The Commission has issued the enclosed Amendment No. 24 to Facility Operating License No. DPR-31 and Amendment No. 23 to Facility Operating License No. DPR-41 for the Turkey Point Nuclear Generating Units Nos. 3 and 4. The amendments consist of changes to the Technical Specifications in response to your application dated May 21, 1976.

TURKEY POINT NUCLEAR GENERATING UNIT NO. 3

Amendment No. 24
License No. DPR-31

SAFETY EVALUATION BY THE OFFICE OF NUCLEAR REACTOR REGULATION

Figure 3.1-1a

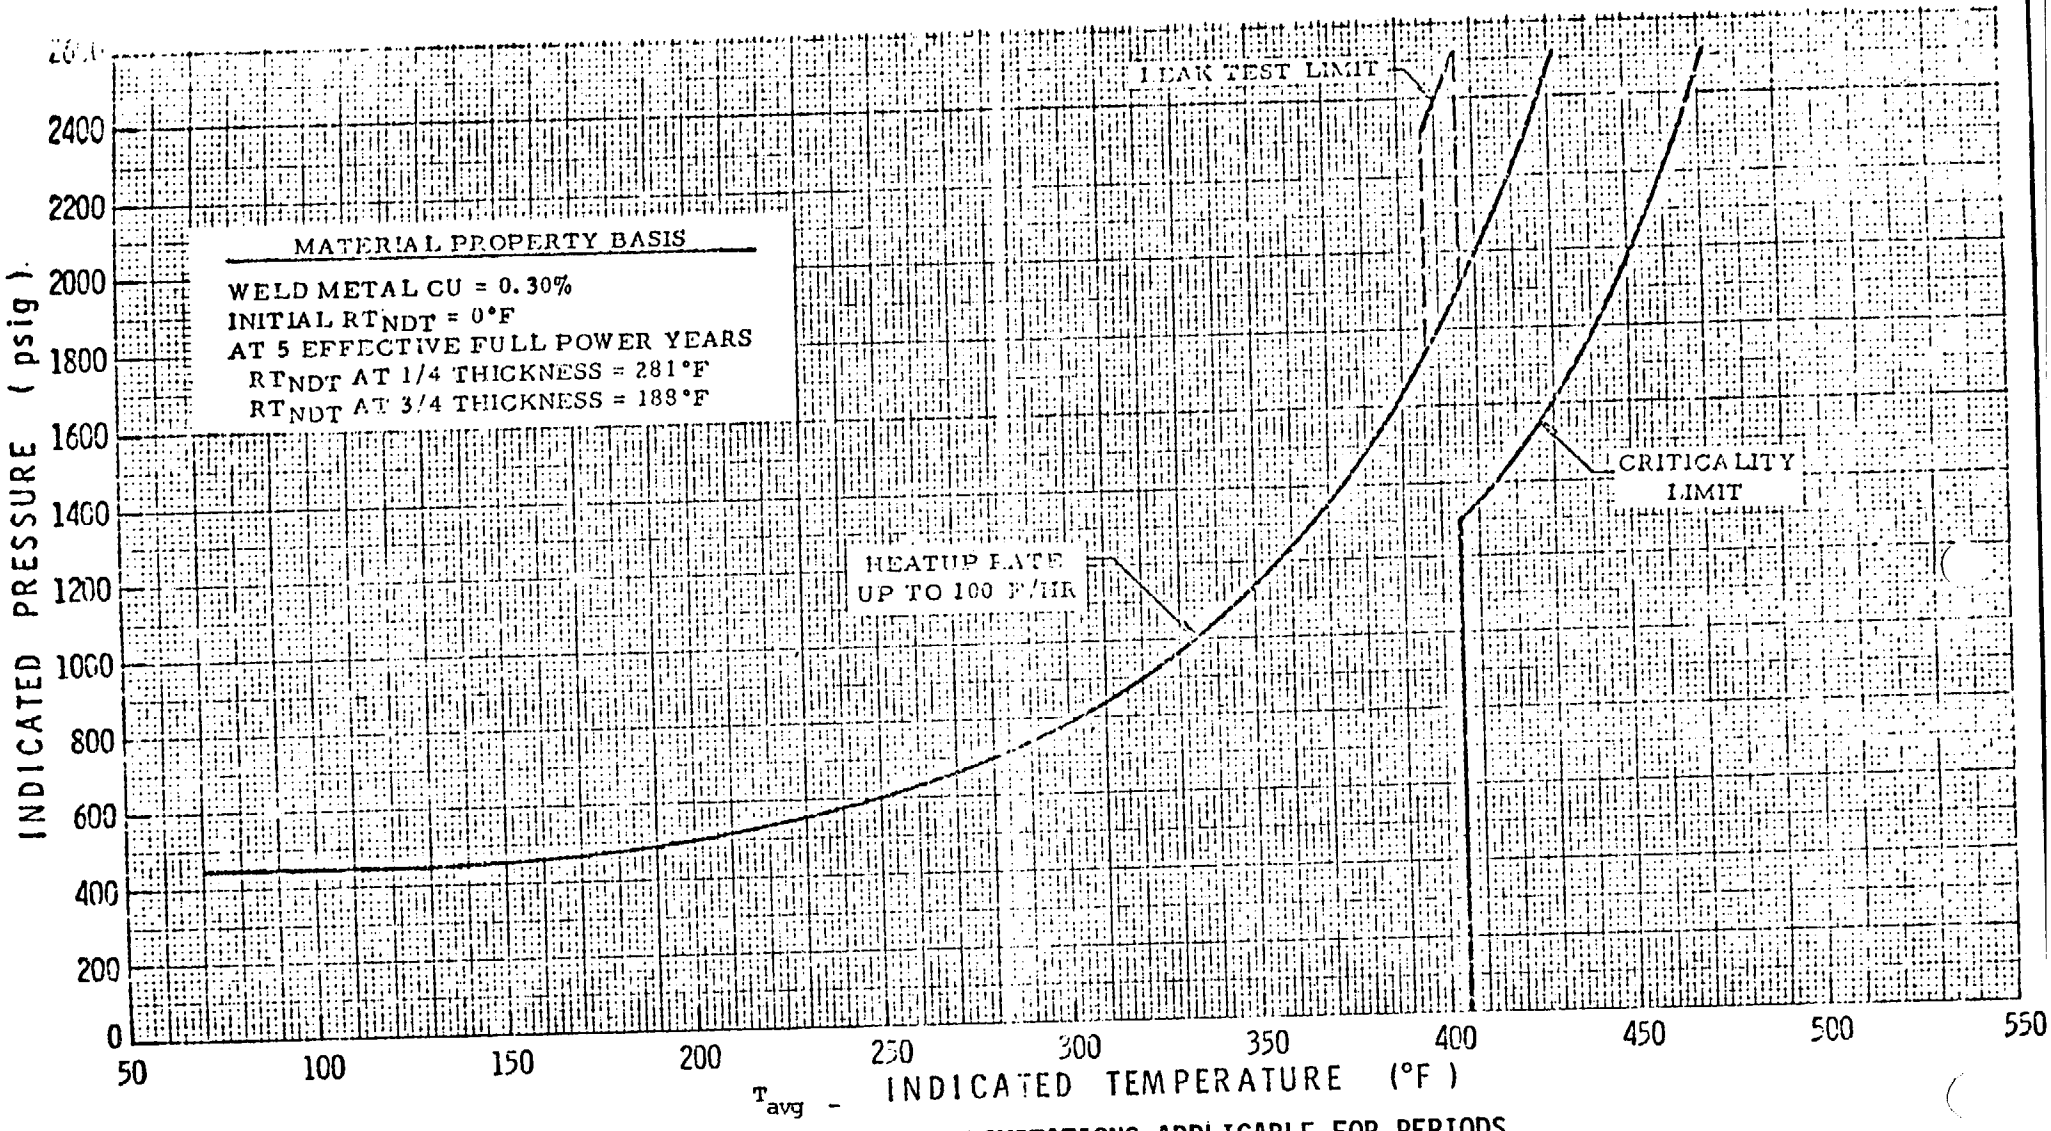
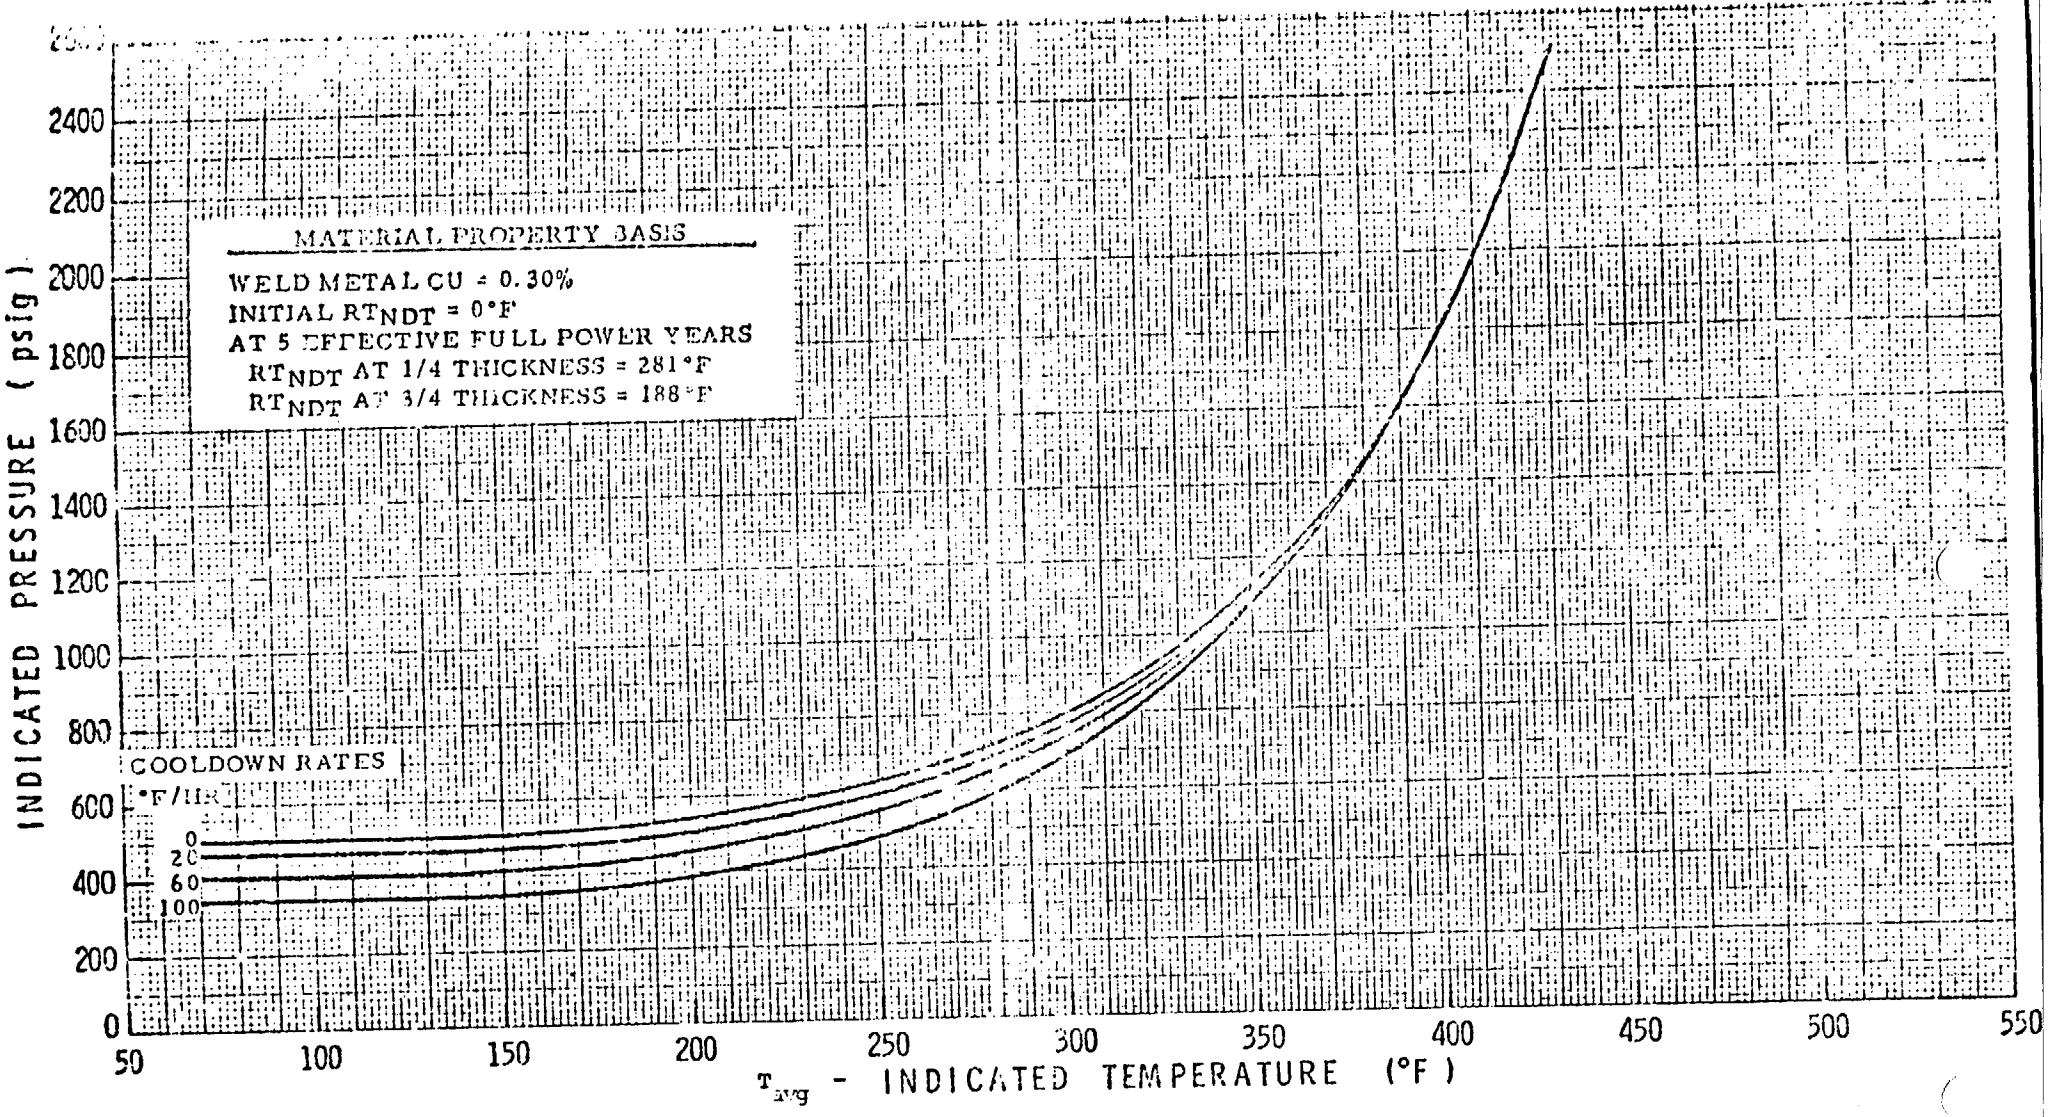
These amendments revise the Technical Specifications to change the reactor coolant pressure-temperature limits to account for neutron irradiation induced increases in reactor vessel metal nil ductility temperature. Please note that the same pressure-temperature limits apply to both Unit No. 3 and Unit No. 4 for five effective full-power years (EFPY).

Replace pages i, v, 3.1-2 thru 3.1-4, and B3.1-1 thru B3.1-4 with the attached revised pages. Replace Figure 3.1-1 with Figures 3.1-1a and 3.1-1b. Add Figures B3.1-1 and B3.1-2.

TURKEY POINT REACTOR COOLANT HEATUP LIMITATIONS APPLICABLE FOR PERIODS UP TO 5 EFFECTIVE FULL POWER YEARS.

TURKEY POINT REACTOR COOLANT COOLDOWN LIMITATIONS APPLICABLE FOR PERIODS UP TO 5 EFFECTIVE FULL POWER YEARS

Figure 3.1-1a TURKEY POINT UNIT 4 REACTOR COOLANT HEATUP LIMITATIONS APPLICABLE FOR PERIODS UP TO 5 EFFECTIVE FULL POWER YEARS.

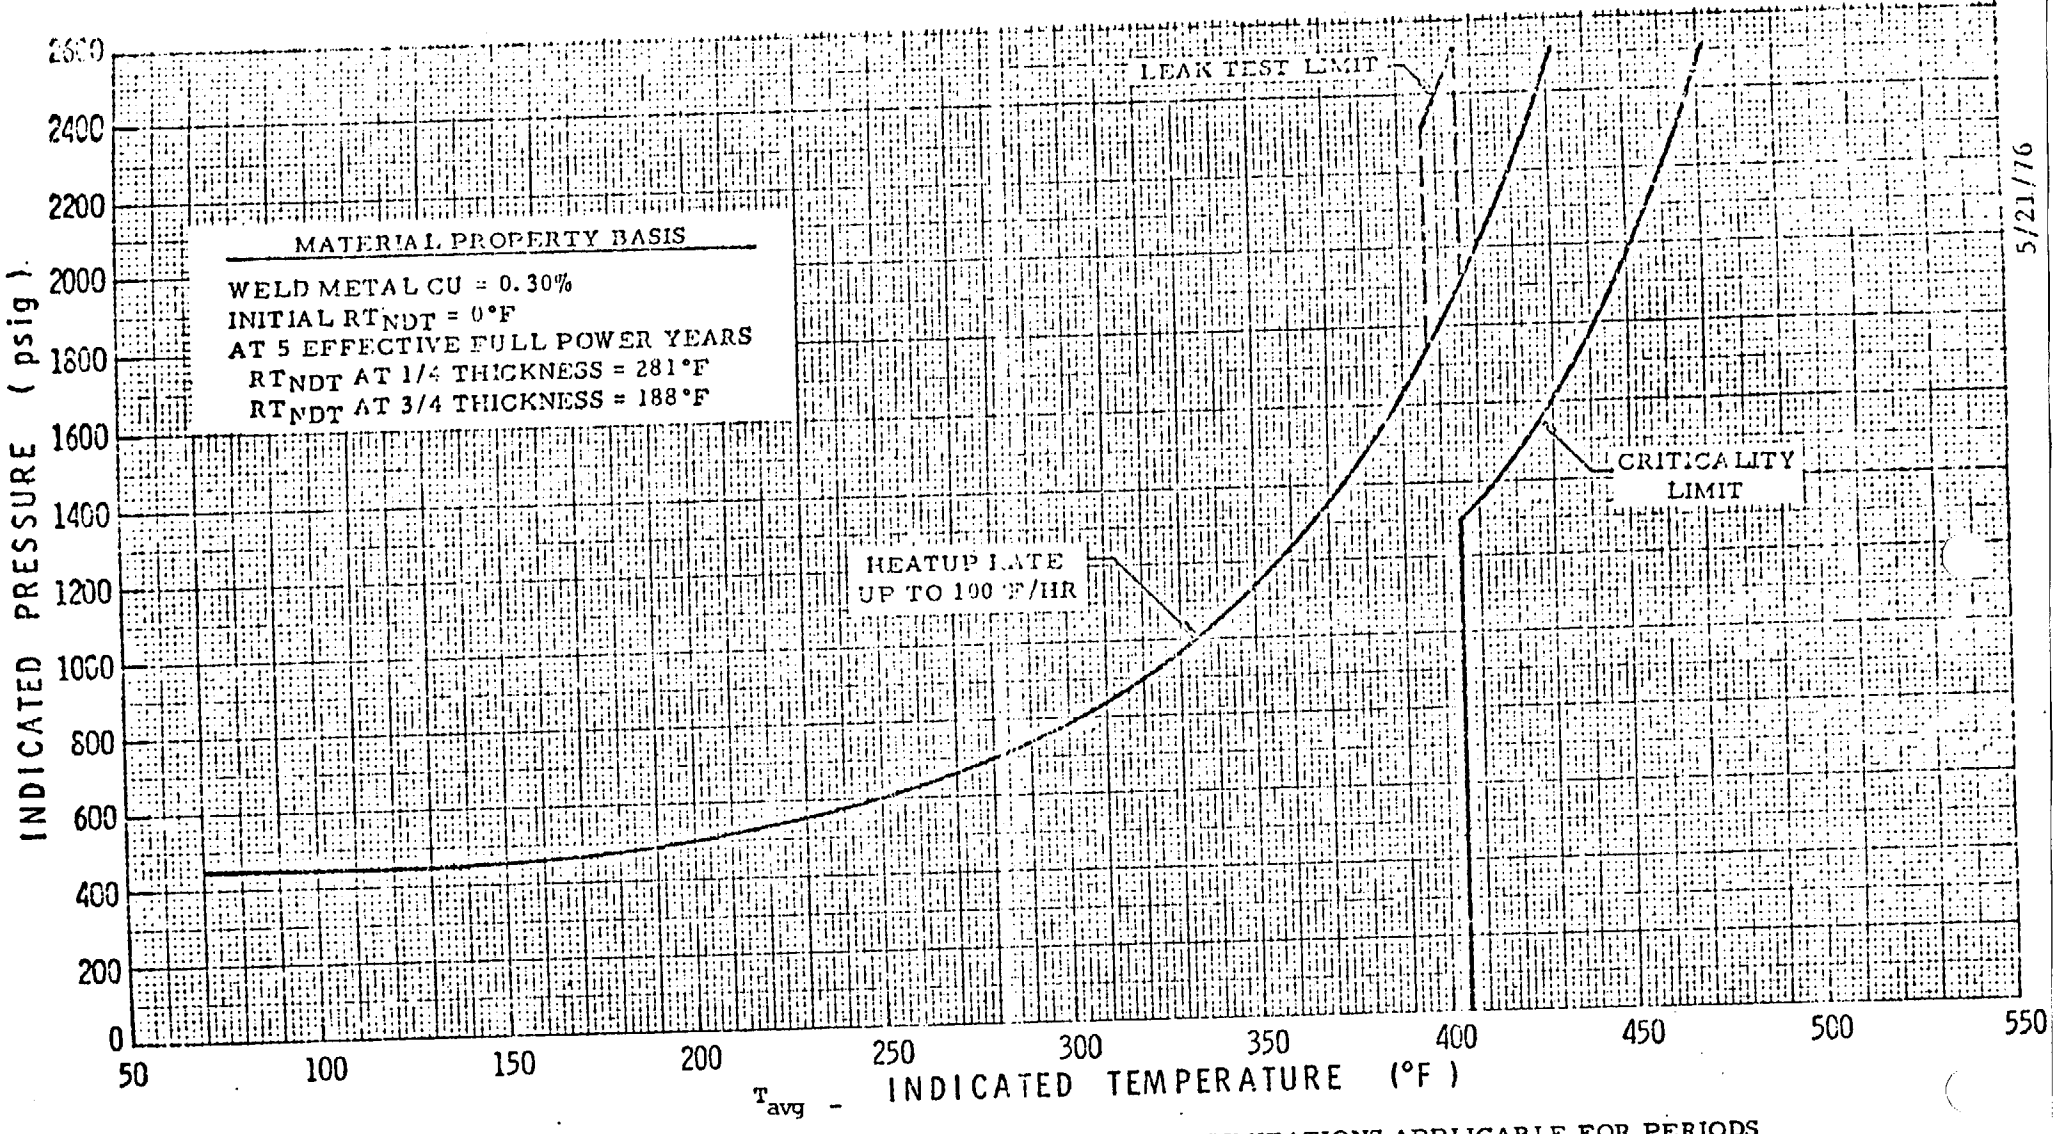
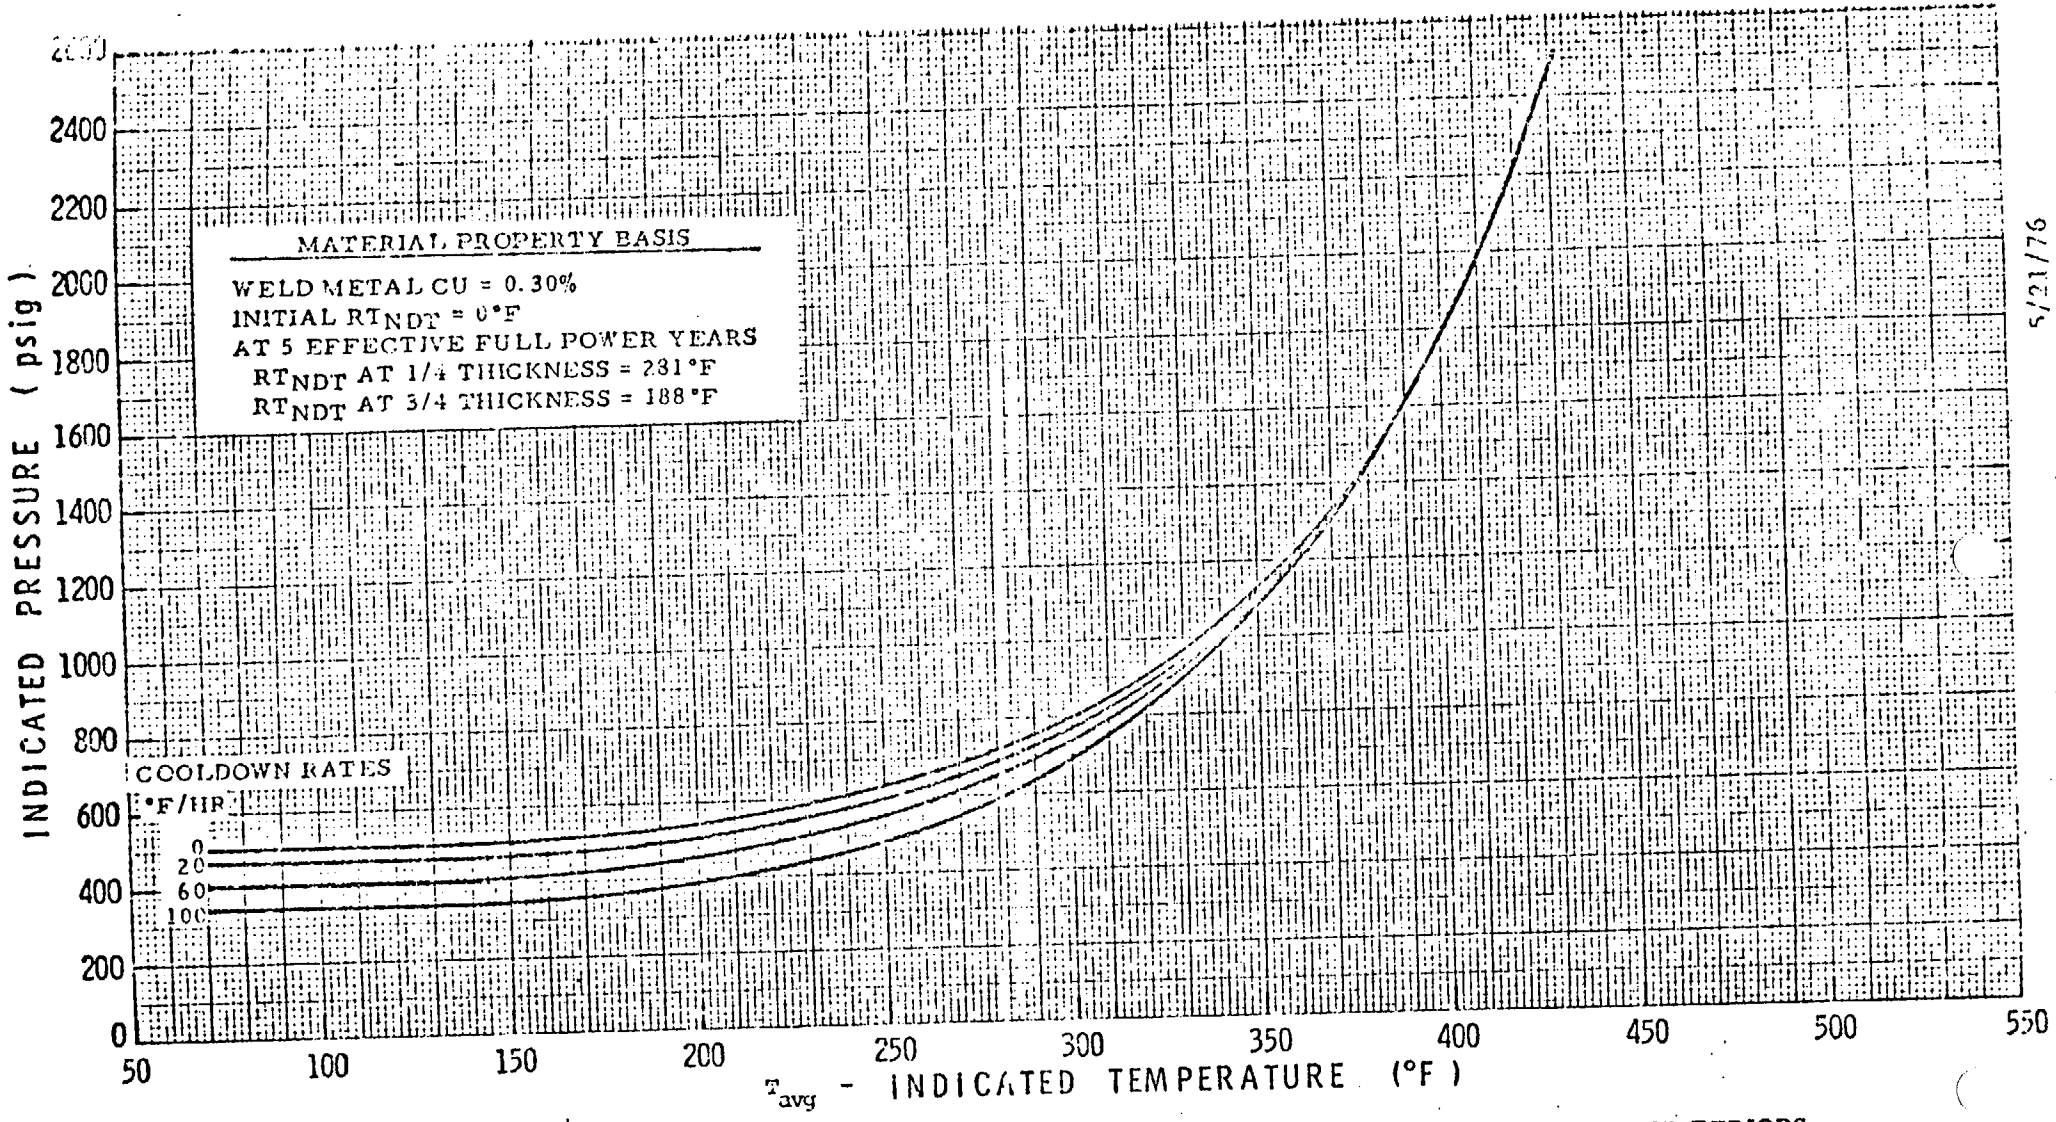
Replace pages i, v, 3.1-2 thru 3.1-4, and B3.1-1 thru B3.1-4 with the attached revised pages. Replace Figure 3.1-1 with Figures 3.1-1a and 3.1-1b. Add Figures B3.1-1 and B3.1-2.

neutron exposure, we have concluded that the more restrictive pressure-temperature limits proposed for Unit No. 4 should also be applied to Unit No. 3. In addition, we are deferring approval of the proposed limits for the period between 5 to 10 EFPYs pending further analysis of the welds in the reactor beltline region.

We have reviewed: (1) the predicted shifts in RT_{NDT} following 5 EFPYs of operation and (2) the reactor coolant system pressure-temperature limits based on these shifts in RT_{NDT}. Based on our review, we have concluded that the revised pressure-temperature limits proposed for Unit No. 4: (1) have been properly determined, (2) specify conservative reactor coolant system heatup and cooldown limits which are applicable to both Units Nos. 3 and 4 and (3) conform to Appendix G of 10 CFR Part 50. Therefore, the pressure-temperature limits proposed for Unit No. 4 for operation up to 5 EFPYs are acceptable for both Units Nos. 3 and 4.
